RFC 467: Proposed Changes to the Public Documents

**Reflects the resultant decisions from the Public-ICWG
September 29, 2021**

RFC 467: Proposed Changes to the Public Documents

Stakeholder Review (CRM) Status

IS800-917, Table 6.2-18

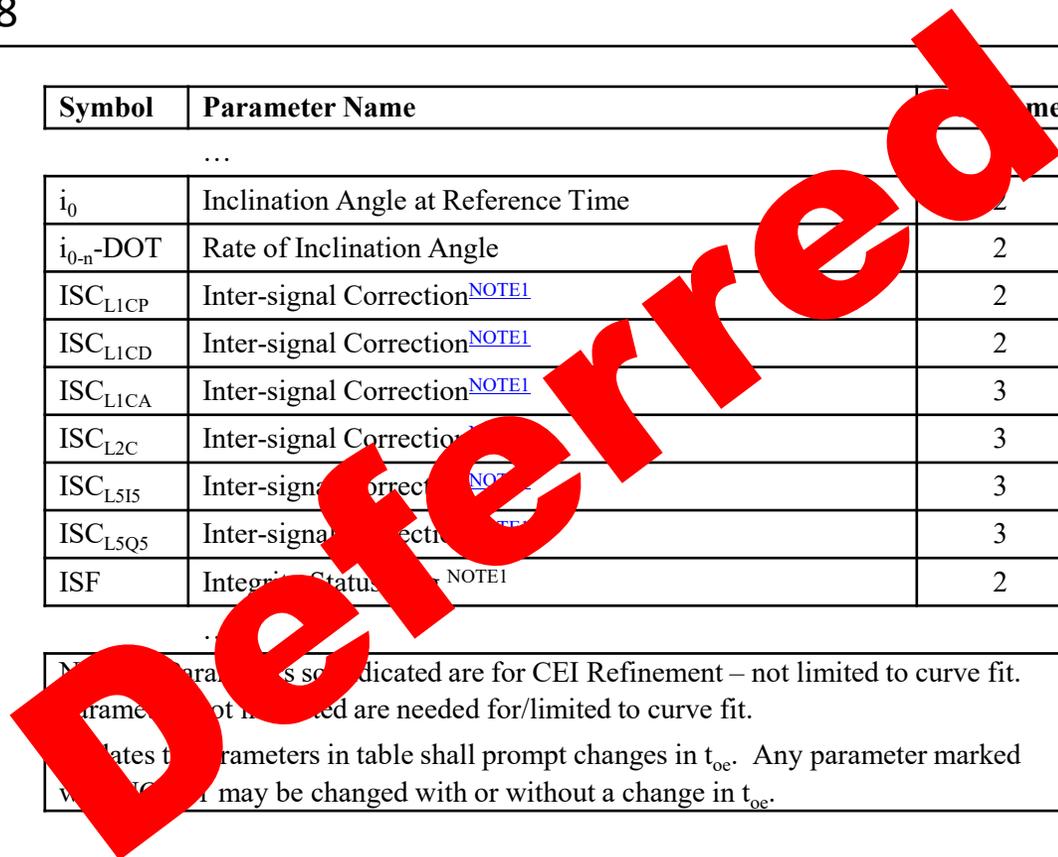
DOORS ID	IS800-917		
Paragraph	Table 6.2-18	Comment Number	244
Comment Type	Substantive	Disposition	Accept <u>Defer</u>
Comment Originator(s)	Jeff Stevens (MITRE)

Comment	<p>The inter-signal correction parameters do not meet the definition of “core CEI” because they are not needed for an initial position solution, and they are not all broadcast to users with the shortest broadcast interval. They should have a "NOTE1" to indicate that they are not considered "core CEI".</p> <p><i>See Table 6.2-18.</i></p> <p><i>Add a superscripted “NOTE1” in the second column after the names of the following parameters: ISC_{L1CP}, ISC_{L1CD}, ISC_{L1CA}, ISC_{L2C}, ISC_{L5I5}, ISC_{L5Q5}</i></p> <p>(13) RATIONALE FOR CHANGE: Consistency with "core CEI" definition</p>		
Government Response	<p><u>Deferred at Public ICWG to study what is “core CEI” more thoroughly</u> (See next slide for proposed changes)</p>

Symbol	Parameter Name	Time
...		
i_0	Inclination Angle at Reference Time	2
i_{0-n} -DOT	Rate of Inclination Angle	2
ISC_{L1CP}	Inter-signal Correction NOTE1	2
ISC_{L1CD}	Inter-signal Correction NOTE1	2
ISC_{L1CA}	Inter-signal Correction NOTE1	3
ISC_{L2C}	Inter-signal Correction	3
ISC_{L5I5}	Inter-signal Correction NOTE1	3
ISC_{L5Q5}	Inter-signal Correction NOTE1	3
ISF	Integrity Status NOTE1	2

Table 3.5-92a Maximum Repetition Rates and Maximum Broadcast Intervals Periods.

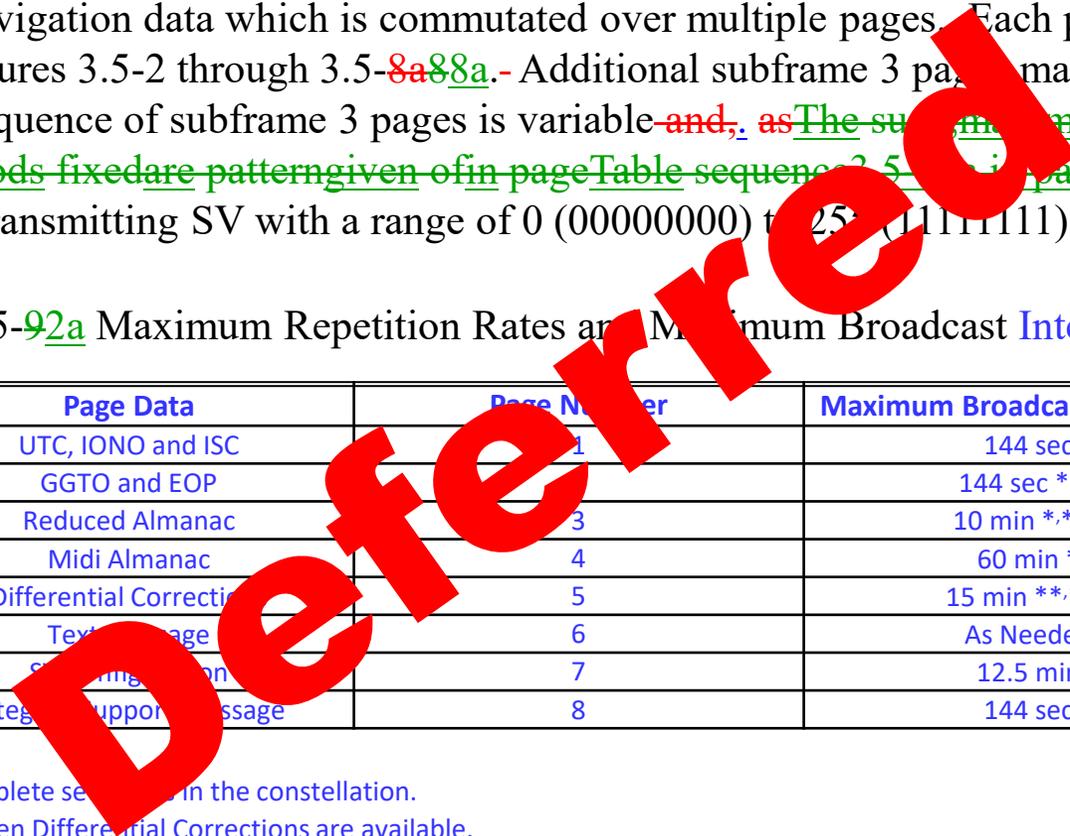
DOORS ID	IS800-140, IS800-1174		
Paragraph	Multiple	Comment Number	242
Comment Type	Substantive	Disposition	Accept <u>Defer</u>
Comment Originator(s)	Jeff Stevens (MITRE)		
Comment	<p>Table 3.5-9 is already in use in IS-GPS-800; see IRN-IS-800G-002 from RFC-413. Assign a new table number to Table 3.5-9 Maximum Repetition Rates and Maximum Broadcast Periods. (13) RATIONALE FOR CHANGE: Consistency</p>		
Government Response	<p>Will convert to Table 3.5-2a Per the Public ICWG, determined this is part of the same issue as <u>CNAV/CNAV2 Message Schedule and Broadcast Interval</u> and needs to be deferred</p> <ul style="list-style-type: none"> <u>IS800-140 is adjusted to remove the reference to Table 3.5-2a</u> <u>IS800-1174 and IS100-1175 are rejected to not add the table</u> <p>(See next slide for proposed changes)</p>

Subframe 3 provides other navigation data which is commutated over multiple pages. Each page of subframe 3 provides different data as shown in Figures 3.5-2 through 3.5-8a88a. Additional subframe 3 pages may be defined in the future. It shall be noted that the broadcast sequence of subframe 3 pages is variable and, as The subframe 3 maximum users repetition must rates not and expect broadcast a periods fixed are pattern given of in page Table sequence 3.5.4. Subframe 3 provides an 8-bit PRN number of the transmitting SV with a range of 0 (00000000) to 255 (11111111).

Figure 40-1 (sheet 4 of 11)

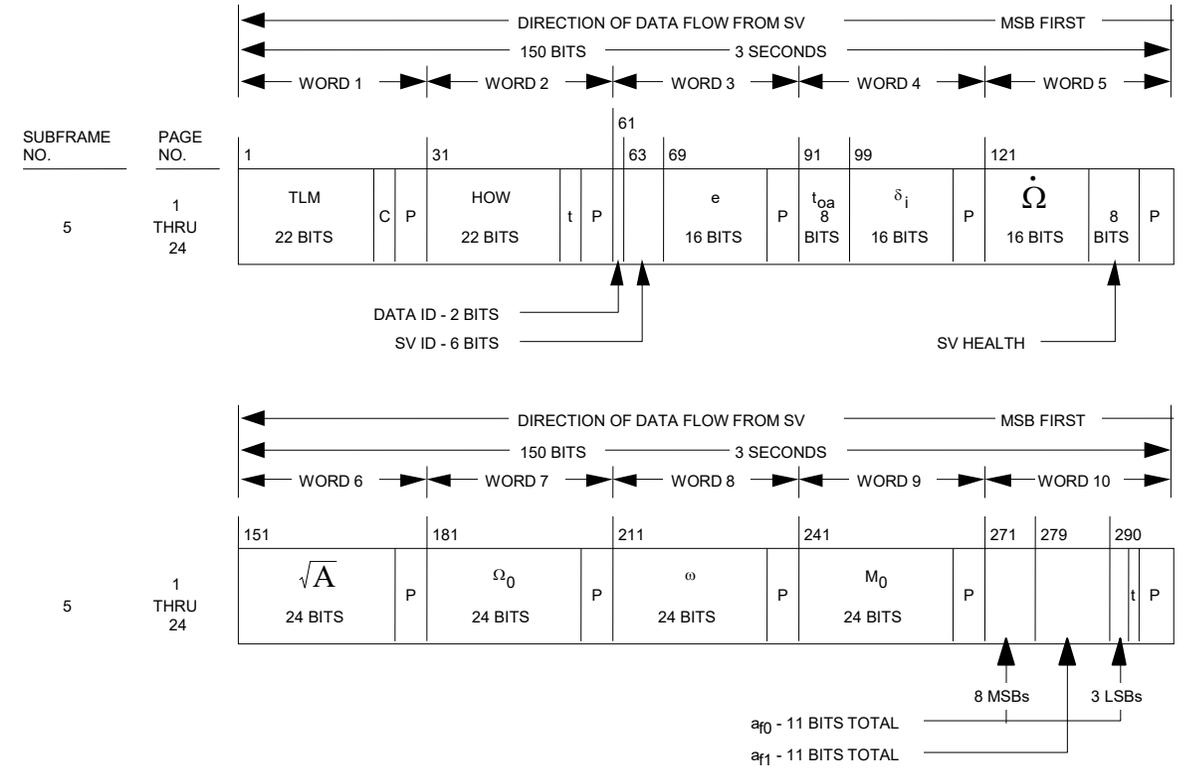
DOORS ID	Figure 40-1 (sheet 4 of 11)		
Paragraph	Figure 40-1 (sheet 4 of 11)	Comment Number	229
Comment Type	Substantive	Disposition	Accept
Comment Originator(s)	Jeff Stevens (MITRE)		
Comment	Because SF4:P10 is not used for almanac in the LNAV-U data structure, it should be removed from sheet 4 that depicts the format of the almanac pages.		
Government Response	(See next slide for proposed changes)

In the NOTE below the figure, change "... PAGES 2, 3, 4, 5, 7, 8, 9 & 10 OF SUBFRAME 4 ..." to "... PAGES 2, 3, 4, 5, 7, 8 & 9 OF SUBFRAME 4 ..."

Figure 40-1 (sheet 11 of 11)

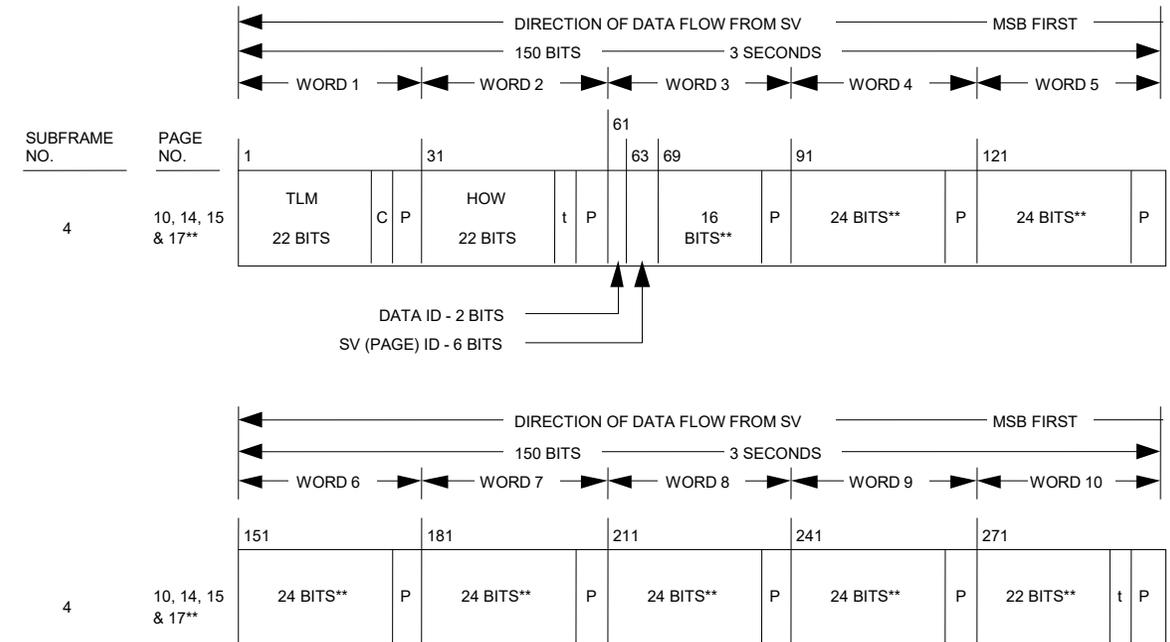
DOORS ID			
Paragraph	Figure 40-1 (sheet 11 of 11)	Comment Number	230
Comment Type	Substantive	Disposition	Accept
Comment Originator(s)	Jeff Stevens (MITRE)		
Comment	Because SF4:P10 is not used for almanac in the LNAV-U data structure, it should be added to sheet 11 that depicts the format of the "reserved and special messages" SF4 pages.		
Government Response	(See next slide for proposed changes)

Under "PAGE NO" , change both occurrences of "14, 15 & 17**" to "10, 14, 15 & 17**".
 In the double asterisk footnote below the figure, change "... OF PAGES 14 AND 15 ARE RESERVED FOR SYSTEM USE ..." to "... OF PAGES 10, 14 AND 15 ARE RESERVED FOR SYSTEM USE ...".
